**From:**  
**To:** [Future Merton](#)  
**Cc:**  
**Subject:** Consultation on main modifications to Merton's draft Local Plan  
**Date:** 22 March 2024 12:04:50  
**Attachments:** [Main Modifications Comments.docx](#)

## The Residents' Association of West Wimbledon

Please find below comments from the Residents' Association of West Wimbledon (RAWW) on the proposed Main Modifications. Our comments are primarily on:

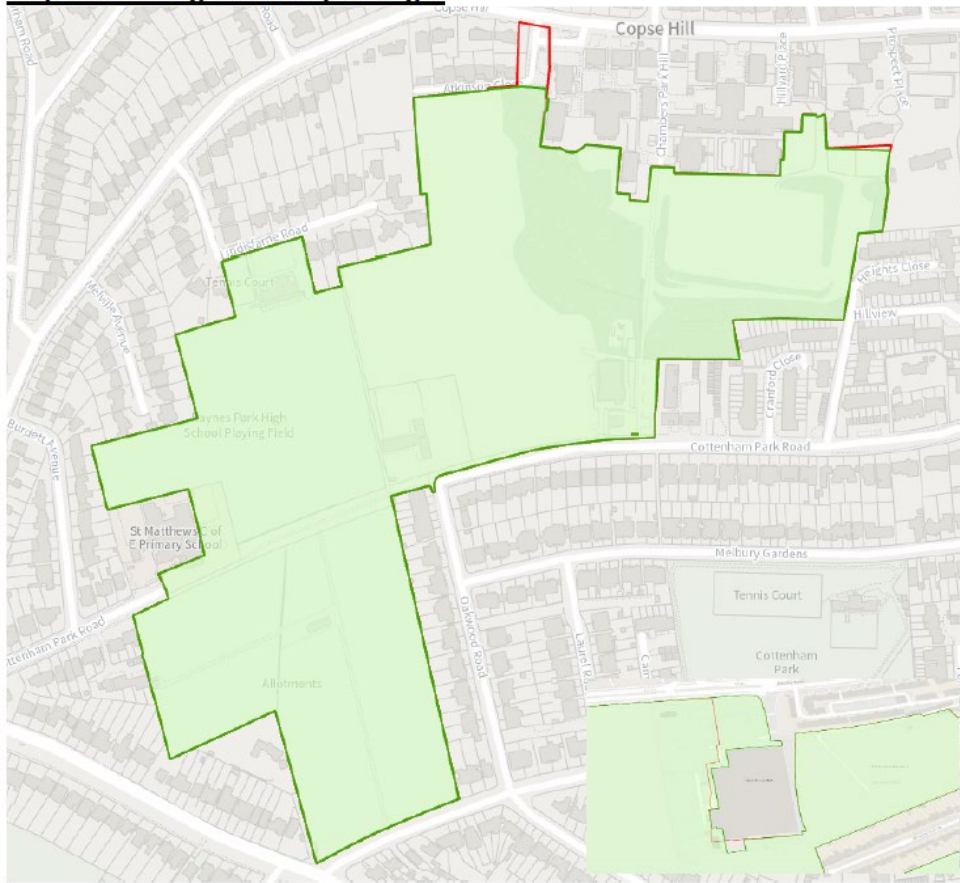
Suggested amendment to e. and f. - Instead of just considering the 'amenity value' of trees proposed for removal and replacement trees both the 'amenity and ecological value' of the trees should be considered.

Suggested addition to f. - 'consist of appropriate species native to the UK and of a trunk girth that matches the girths of the lost trees'.

Replacing mature trees lost to make way for development with an equal number of young trees will reduce tree canopy cover and not be of equal amenity and ecological value. There needs to be some guidance in the plan on how the 'value' of the trees will be measured.
